ADDENDUM #01

General Site – Landscape Services Greenhouse Relocation and New Salt Shed

PROJECT NUMBER: CP231543

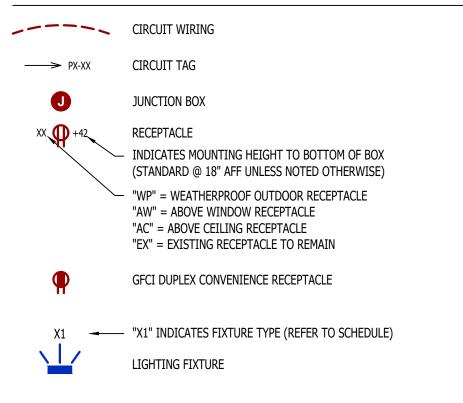
- 1. MEP102
 - a. Clarify tap for FPHB is before blow down pit.
